Work Order ID 161674

DWG NO. 646.9700

DWG TITLE: CUTTER SUB ASSY

DART AEROSPACE APICAL INDUSTRIES, INC. dba DART AEROSPACE	ENGINEERING CHANGE NOTICE NO.		05345		SHEET 1 OF 1	
	DWG NO.	646.9700	REV:	D	PREPARED BY	J. GARDINER
	DATE:		03/15/16		EFFECT ON DWG ☐ INC. ☒ UNINC.	
	DWG TITLE: CUTTER SUB ASSY					
APPROVED BY:		ENGR.	MFG		QC	EFF. CURRENT ORDER
TRANSACTION CODES (TC): A-ADD R-REVISE C-CREATE D-DELETE		REASON: REVISED NOTES				ECR: N/A

SHEET 7, ZONE C3 IS:

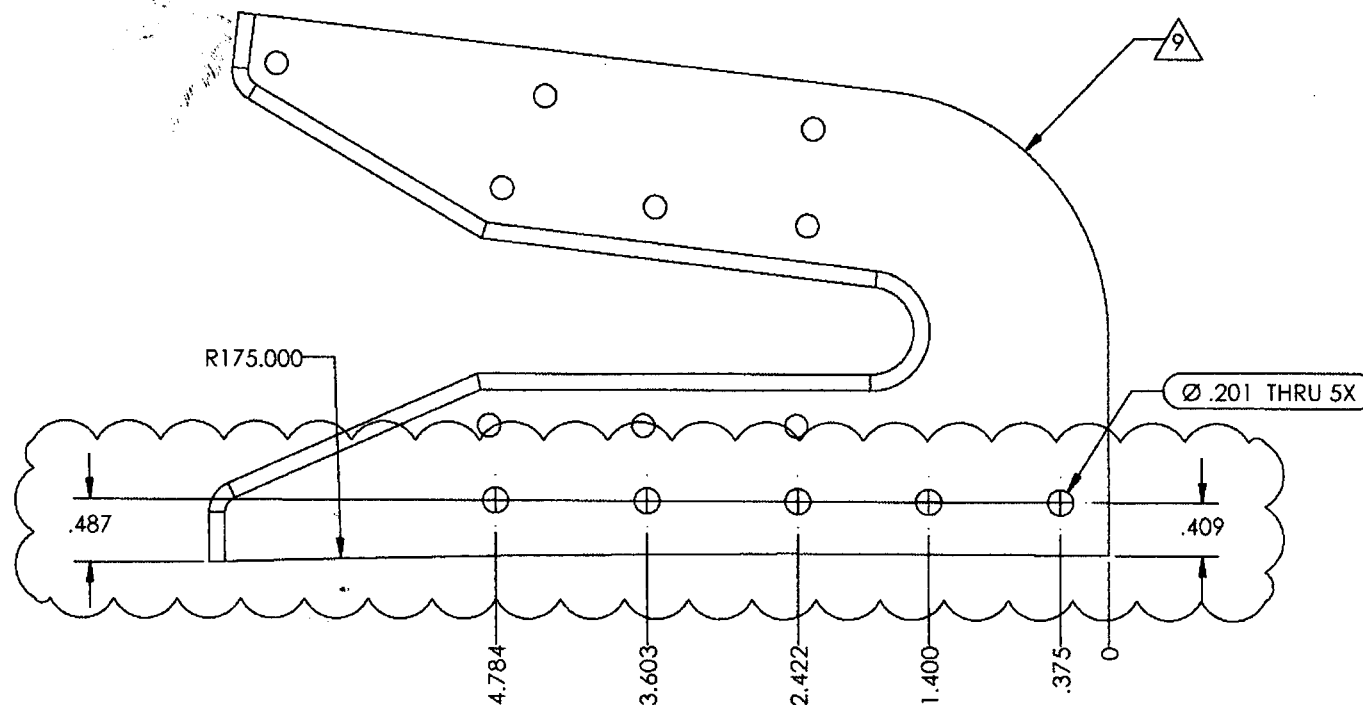
REASON: REVISED DIMENSIONS

SHEET 1, ZONE A6 IS:

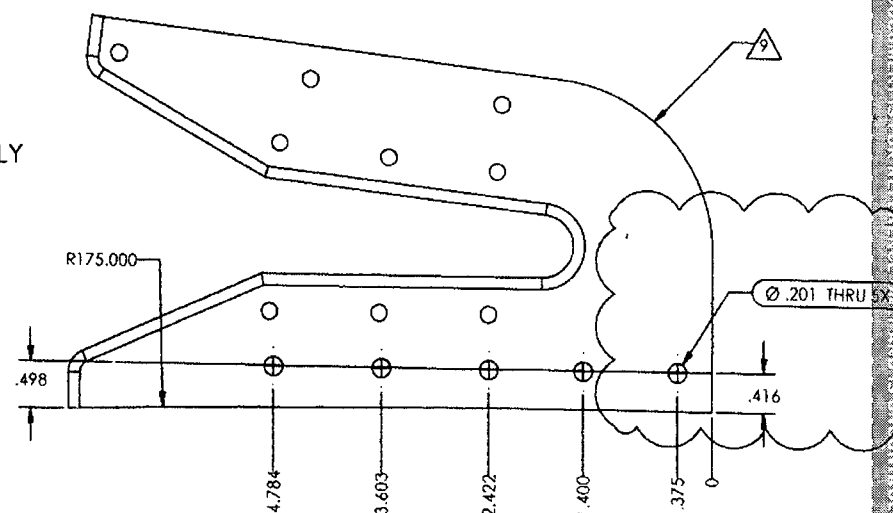
IS

- 1 MATERIAL: ALUMINUM 7075-T651 PER AMS-QQ-A-250/12
- 2 FINISH IAW MPP-172 SECTION 2.1, 3.3 & 4.3.
- 3 MATERIAL: AISI A2 TOOL STEEL
CONDITION: ANNEALED
POST PROCESS: HEAT TREAT TO 58-62 Rc ROCKWELL HARDNESS
- 4 FINISH: PRIME IAW MPP-172 SECTION 3.3; 1-2 MIL MAX
5. DEBURR AND BREAK ALL SHARP EDGES EXCEPT WHERE OTHERWISE NOTED
6. IDENTIFY IAW MPP-120
- 7 APPLY F/N 5 AS REQUIRED TO ALL FAYING SURFACES OF F/N 2 UPON ASSEMBLY
- 8 CUTTING EDGE INTENDED TO BE SHARP, DO NOT BREAK SHARP EDGE
- 9 ALL DIMENSIONS NOT SPECIFIED ARE CONTROLLED BY 646.9710.
